Interactive comment on “Balancing energy and environmental concerns: the case of the Kayraktepe dam, Turkey” by Ö. Sever et al.

We would like to thank for the valuable comments of the reviewer #1. We have reviewed referee' suggestions, and the necessary changes and explanations will be made in the revised article. An item-by-item summary of our responses to the review comments is provided in this sheet.

Fig. 1. Figure 1b

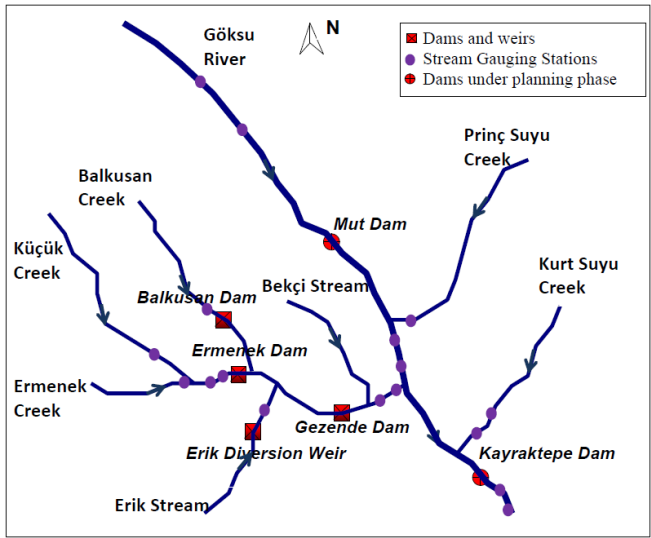
We will arrange Table 1 according to your and editor' suggestions. Page 11773 (line 13) figure 1 is not very clear. It would be useful to indicate which dams have been built and which are planned.

The Figure 1 is placed very small, we will ask editor if they can enlarge it. In addition we re-draw the Figure 1 which is attached.

Fig. 2. f

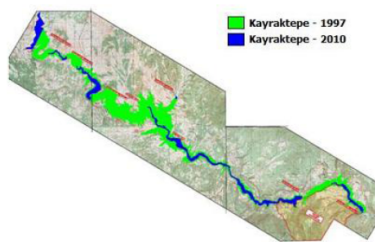
Technical corrections The English could be tightened somewhat. The figures are not very clear and could be improved by including more detail. A figure showing the difference in area inundated by the different schemes would be useful

dropower plants. The main dam has a height of 53 m and the total lake area will be 820 ha. Number of inundated villages located in upstream of the dam was 43 and it will force about 2200 people to resettle elsewhere according in Kayraktepe-1982 schema. It is reported that there will be 11 village with 5000 ha land will be flooded if Kayraktepe 1997 will be realized. However, In Kayraktepe 2010 schema, a dramatic reduction in expropriation area by % 83.5 was achieved, where originally 5000 ha area was reduced to approximately 820 ha. None of the villages at the upstream will be inundated. A plan view of Kayraktepe-1997 and Kayraktepe-2010 alternatives were prepared by using a 1/25000 scaled topographic map and can be seen in Figure 3.
